CITY OF NEW BERLIN
PLAN COMMISSION MEETING
Monday, January 10, 2022
VIA ZOOM
https://us02web.zoom.us/j/85912309075

APPLICANT/PROJECT:	**Jim Hart with the New Berlin Utility Department / Reconstruction of the Westridge Lift Station**
LOCATION:	**15451 W. Beloit Road (Tax Key #: 1254.993.001) (also referred to as 4950 S. Moorland Road (Tax Key #: 1254.982) in City files)**
REQUEST:	**Conditional Use Permit for the New Berlin Utility Department to reconstruct the Westridge Lift Station, located at 15451 W. Beloit Road.**
D.R.C. RECOMMENDATION:	**Approval of the Conditional Use Permit for the New Berlin Utility Department to reconstruct the Westridge Lift Station, located at 15451 W. Beloit Road, subject to the application, plans on file and the following conditions of approval:**

CITY OF NEW BERLIN
DEPARTMENT OF COMMUNITY DEVELOPMENT
PLAN COMMISSION STAFF REPORT

DRAWING TITLE
SITE PLAN

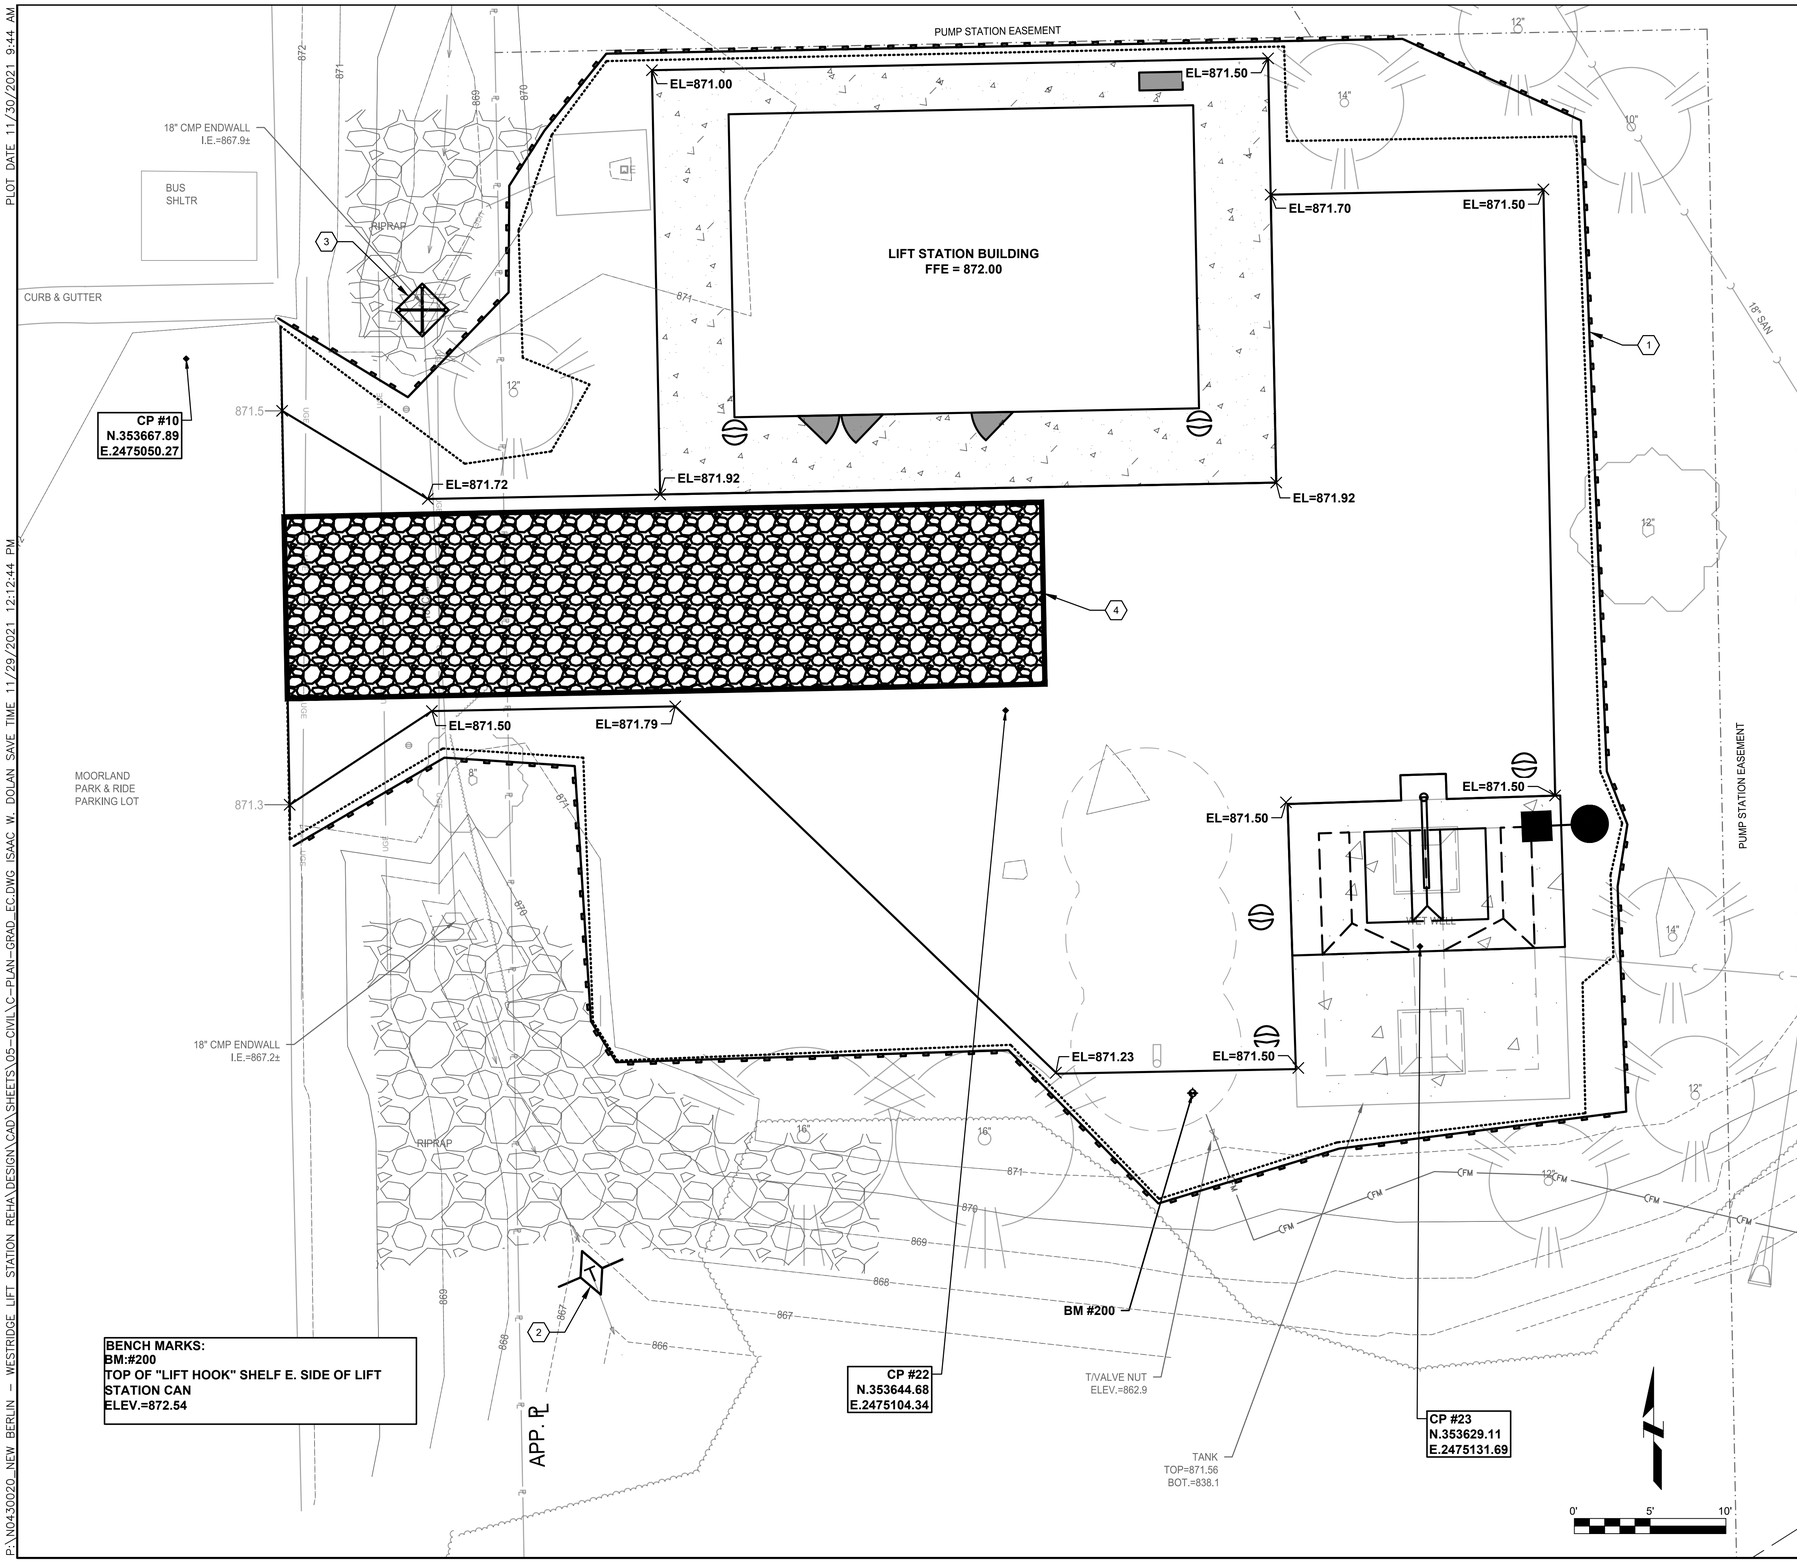
3. **Engineering:**
    a. **Permission is required if construction staging is needed from the WisDOT Park and Ride lot.**
    b. **Plan does not show any building lighting for evening access or security purposes.**
